Preliminary Drainage Report
for
Rolling Hills Ranch North
at
Meridian Ranch

September 2023

Rolling Hills Ranch North PUD Preliminary Drainage Report

FIGURE 6

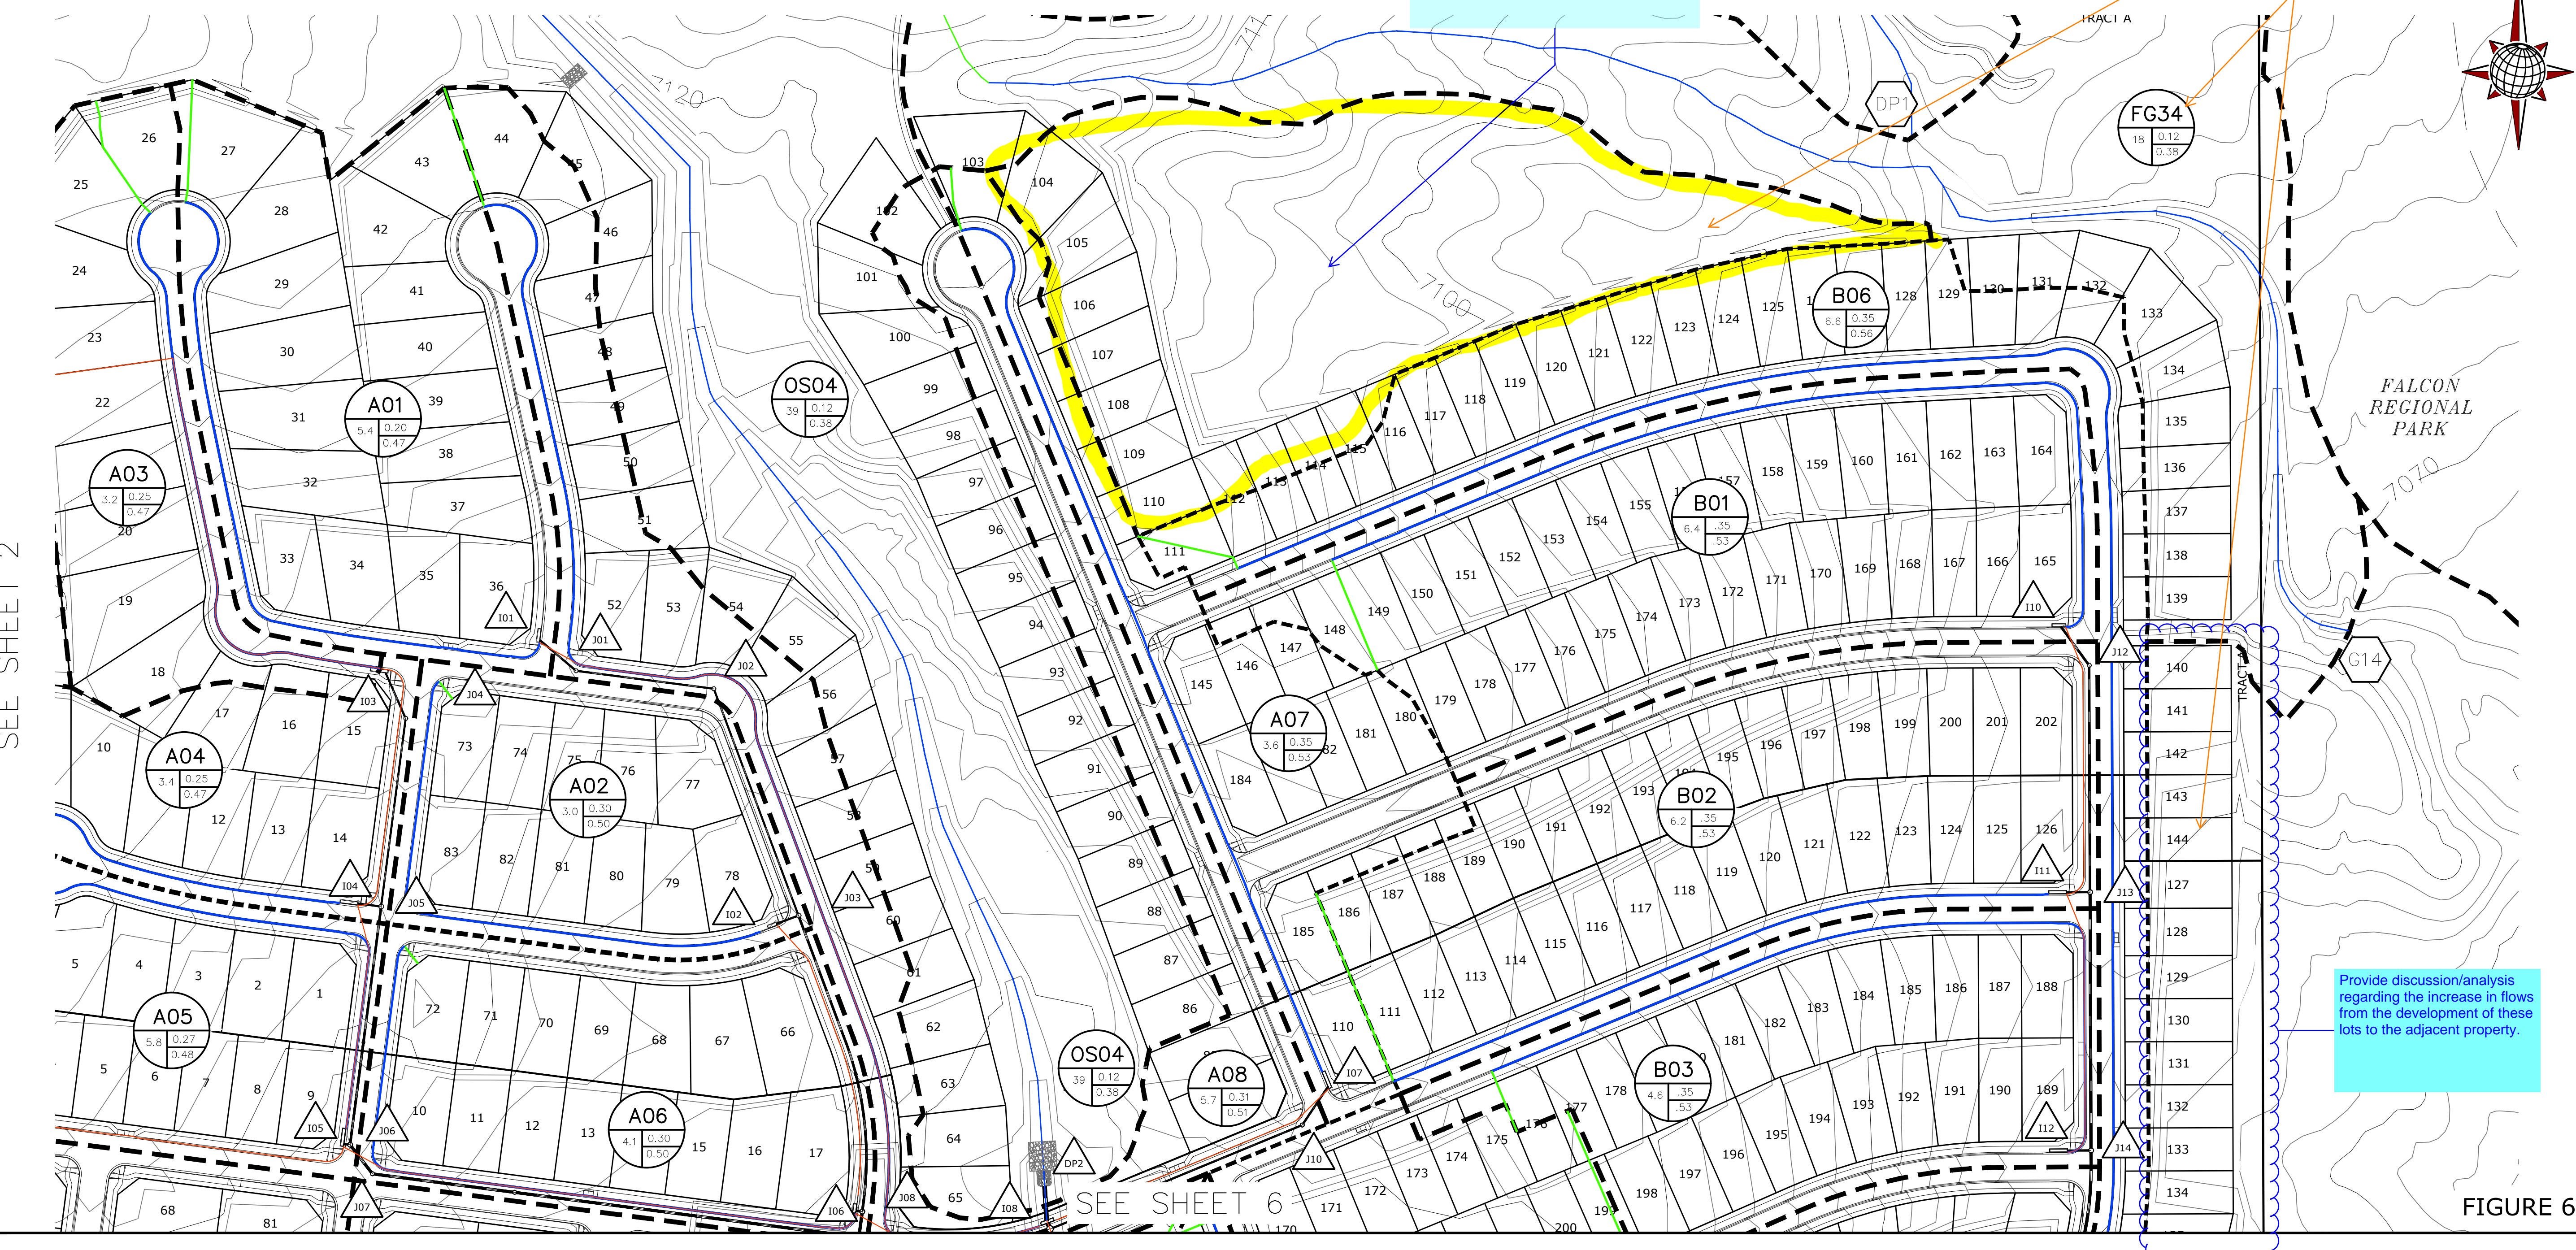
Provide discussion/analysis of this basin as well as basin FG34. Identify whether the channel within basin FG34 was designed to account for the developed flows of the lots in this basin and FG34.

Provide discussion/analysis regarding the increase in flows from the development of these lots to the adjacent property.

FIGURE 6

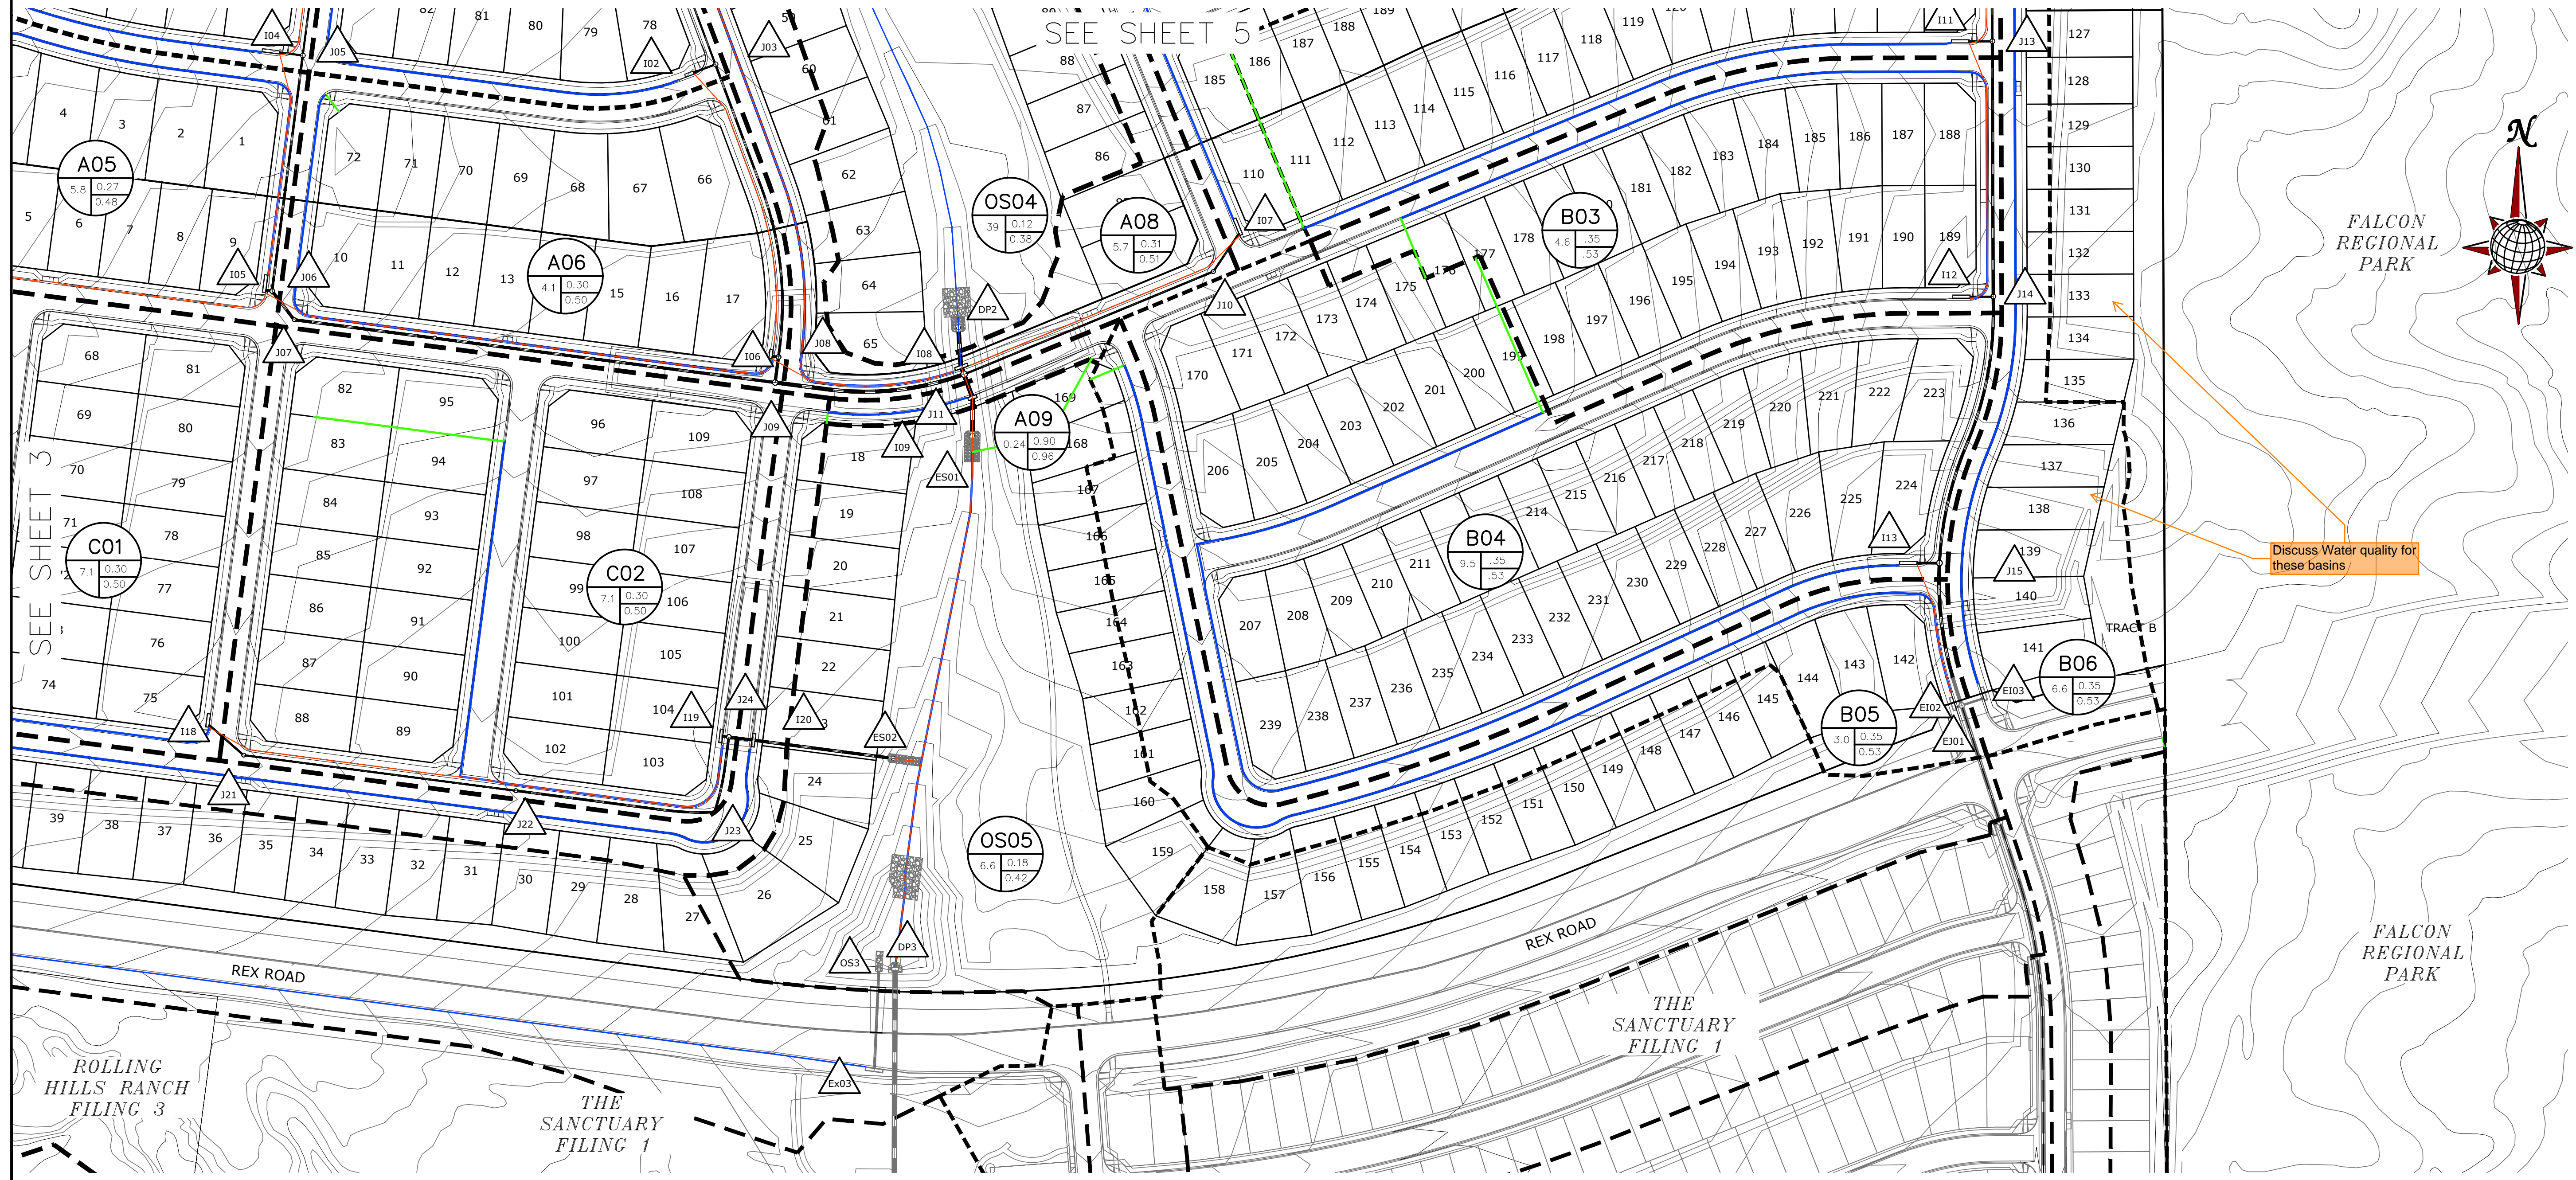
please provide flows for DP ES01 and ES02 in the summary table

Discuss Water quality for these basins
